CITY OF ALBUQUERQUE

**RE: Springstone Parking Lot and Garage
9010 Davenport St NW
Grading and Drainage Plan Stamp Date: 10/10/19
Hydrology File: C12D003B2**

SUBJECT: *Springstone Parking Lot and Garage*
9010 Davenport Street NW
Grading & Drainage Plan (C12/D003B2)

C.2

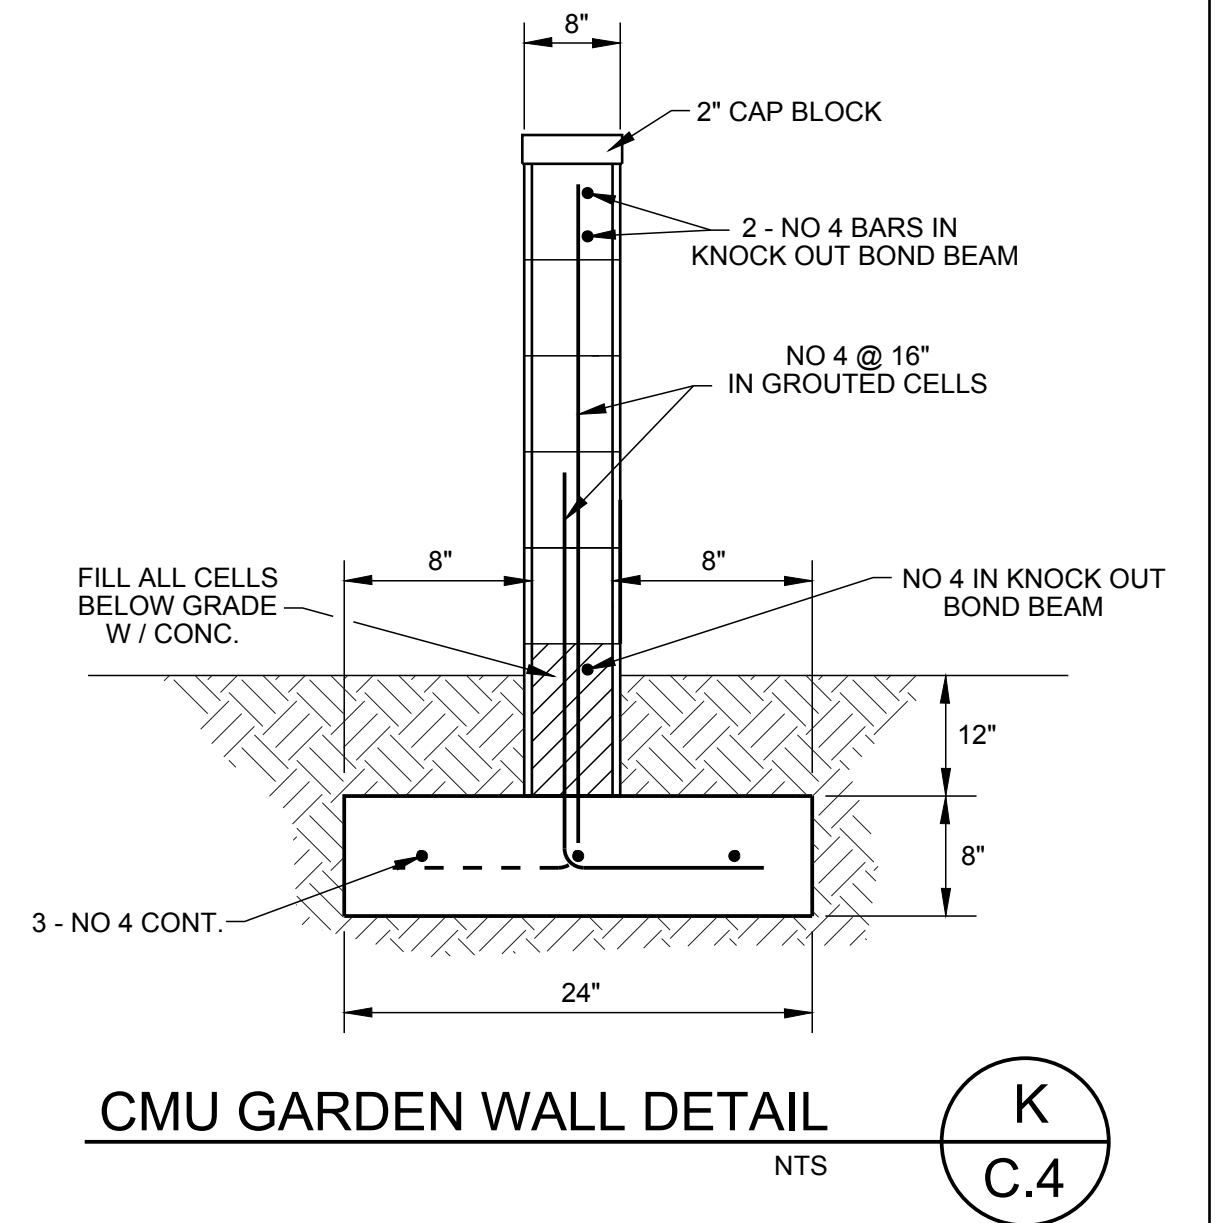
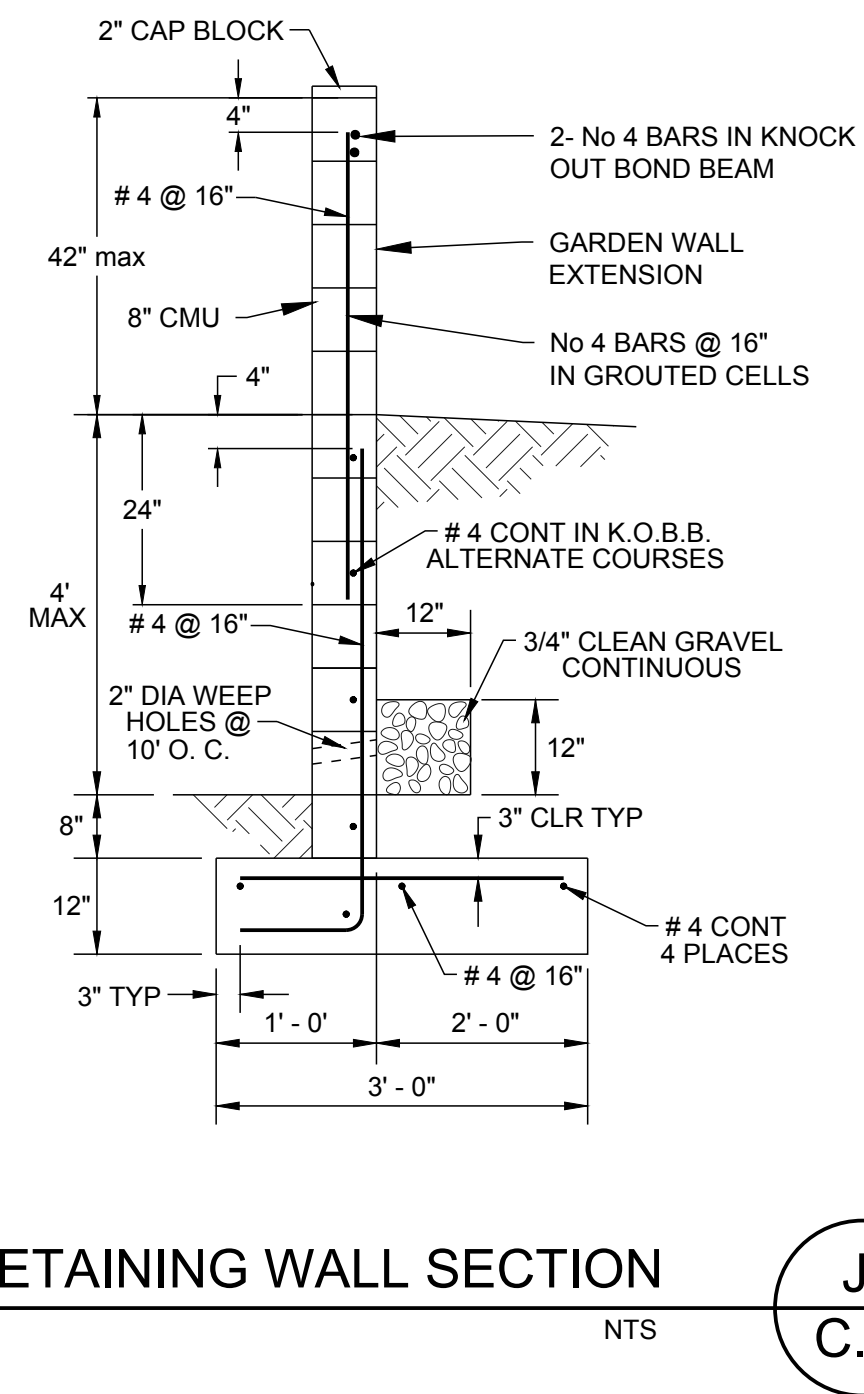
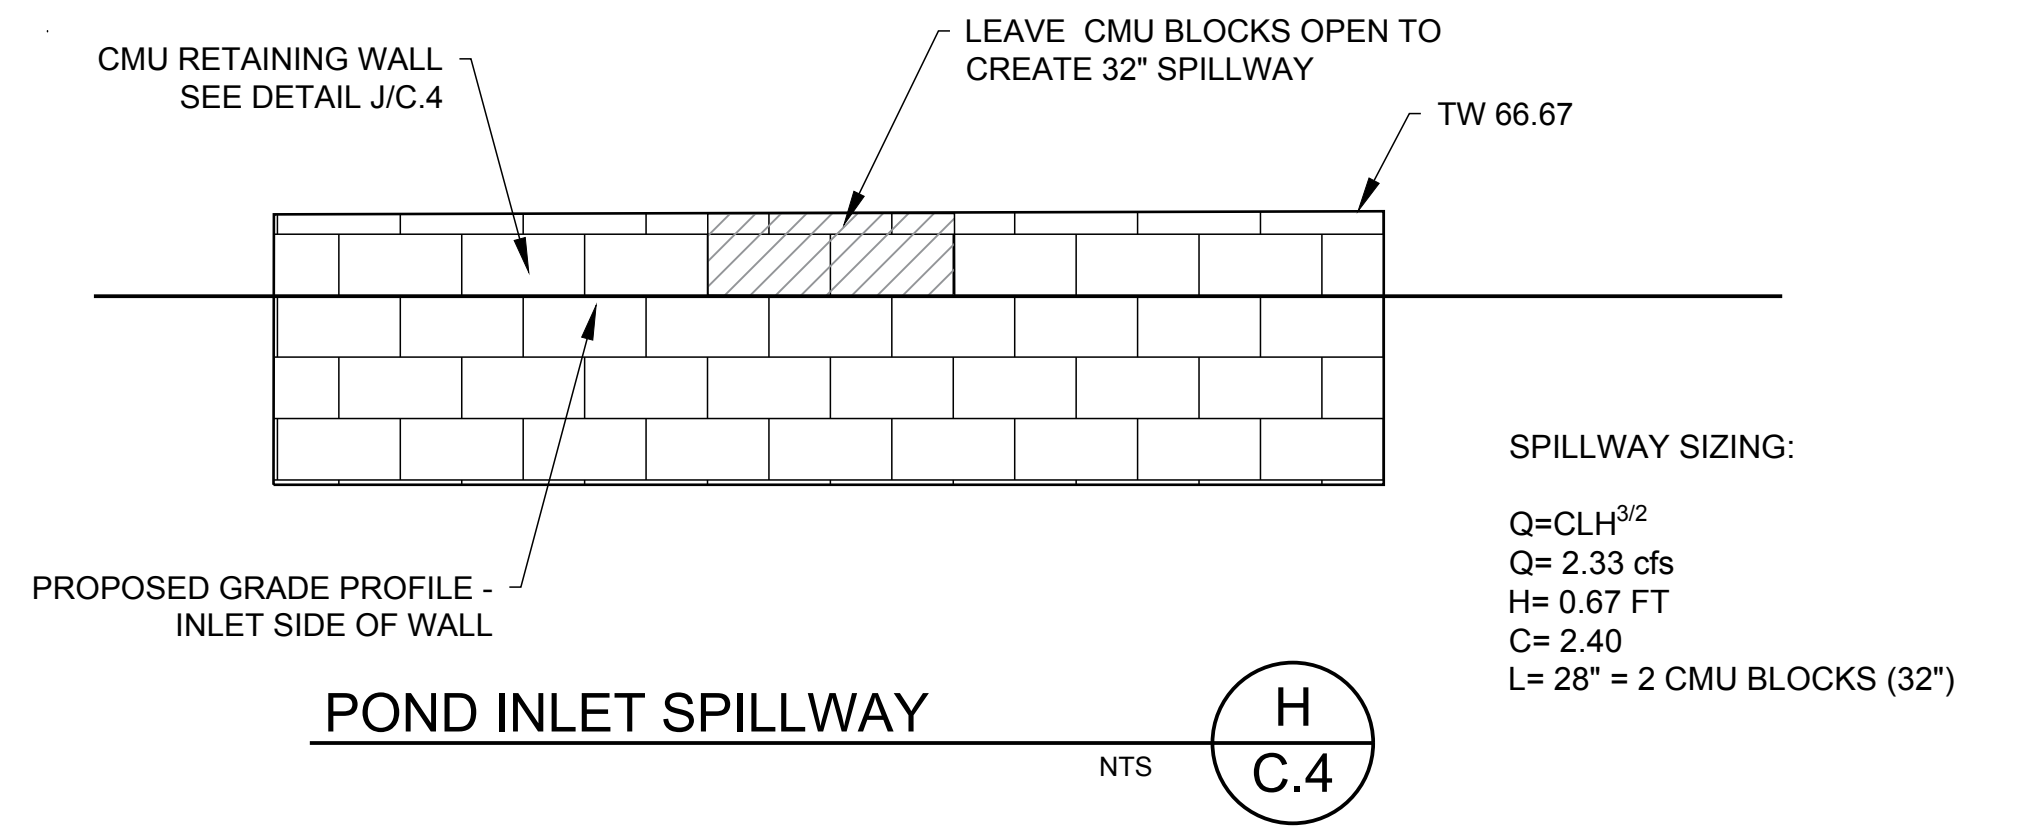
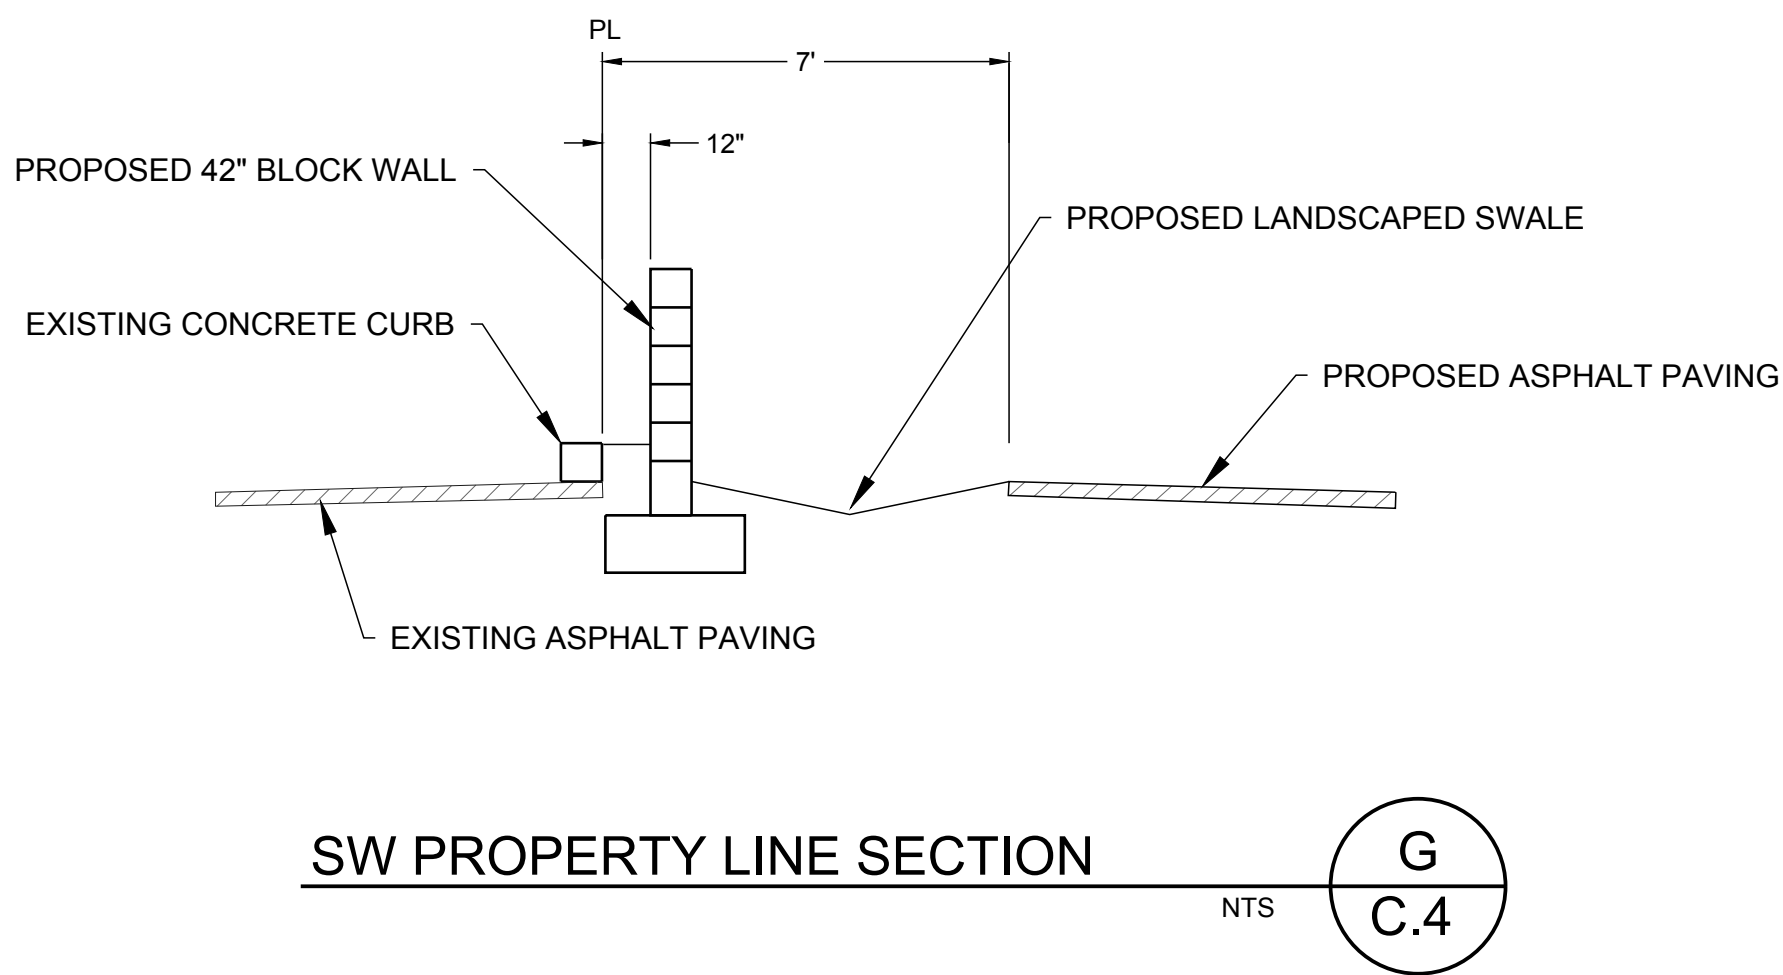
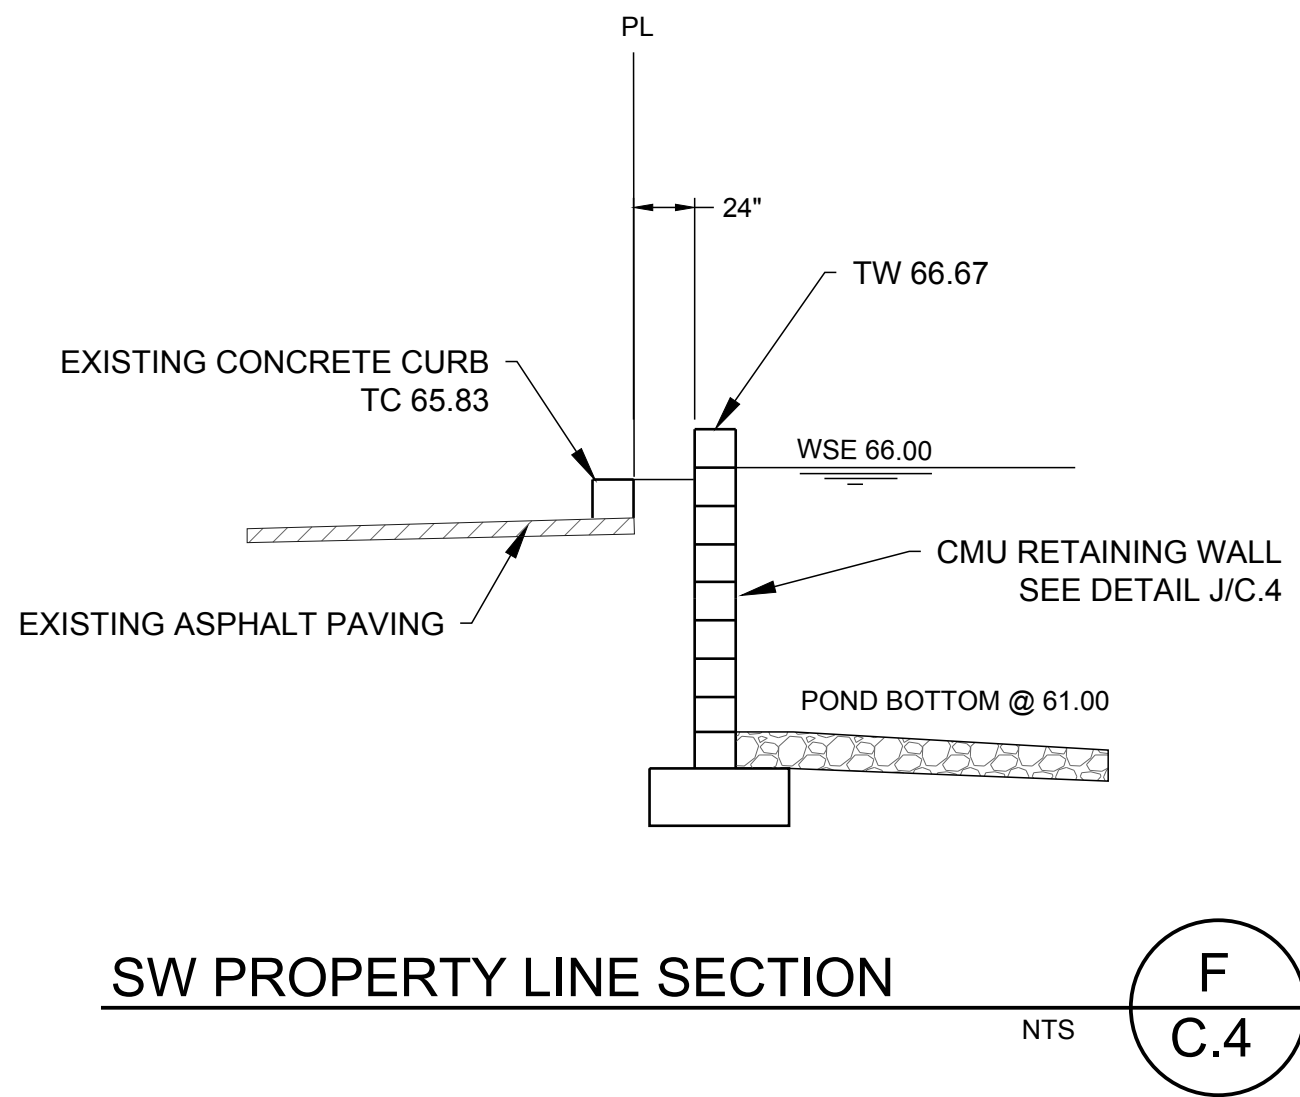
1. To avoid excessive fill and retaining walls the site will implement a 100-year-10-day retention pond.
2. The property address is provided on the Plan.
3. Property line sections are provided on Detail Sheet C.4.
4. The short version of AHYMO for small watersheds was used to calculate developed flowrates and volumes.
5. The project benchmark is provided on the Plan.
6. Attached is an unsigned copy Drainage Covenant. I will submit a signed original to Madeline Carruthers after the G&D Plan is approved.
